SUNDRY NOTICES AND REPORTS ON WELLS (DO NOT USE THIS FORM FOR PROPOSALS TO DRILL OR TO DEEPEN OR PLUG BACK TO A DIFFERENT RESERVOIR. USE "APPLICATION FOR PERMIT" (FORM C-101) FOR SUCH PROPOSALS.)		WELL API NO. 30-015-29404
1. Type of Well: Oil Well ☒ Gas Well ☐ Other ☐		5. Indicate Type of Lease STATE ☒ FEE ☐
2. Name of Operator Harvard Petroleum Company		6. State Oil & Gas Lease No. K-952
3. Address of Operator PO Box 936, Roswell, NM 88202		7. Lease Name or Unit Agreement Name Todd "36J" State
4. Well Location Unit Letter J : 2000 feet from the S line and 1965 feet from the E line Section 36 Township 23S Range 31E NMPM Eddy County		8. Well Number 9
11. Elevation (Show whether DR, RKB, RT, GR, etc.) 3512 GR		9. OGRID Number 10155
		10. Pool name or Wildcat Ingle Wells, Delaware

Harvard Petroleum Company proposes to plug this well as shown on the attached procedure.

Operator: Harvard Petroleum Company
Well Name: Todd "36J" State #9
API# 30-015-29404

Current Wellbore

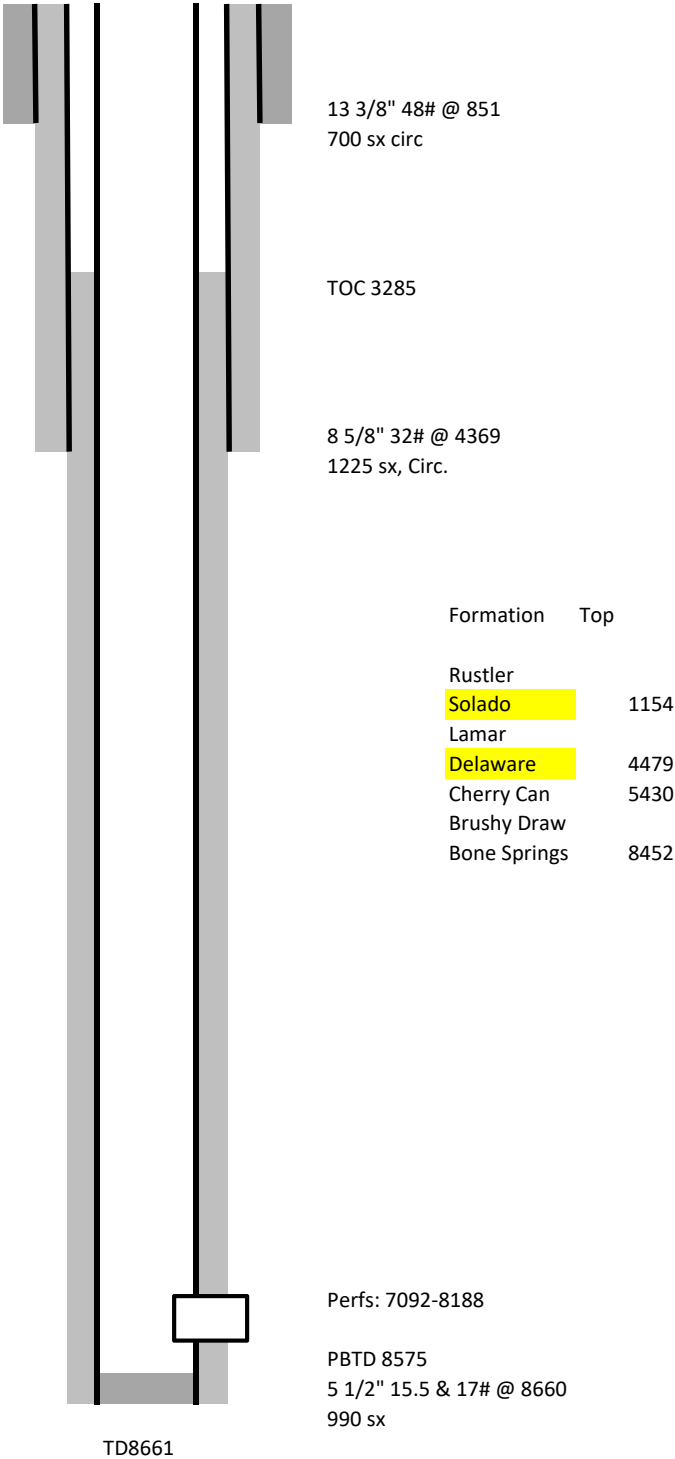
CBL to location

spot 25 sx cl C @ 6753' - 6653' - DV tool - WOC & tag

Spot 25 sx cl C cmt @ 5480' - 5380' T Cherry Canyon - WOC & tag

spot 25 sx cl C @ 5058' - 4958' - DV tool - WOC & Tag
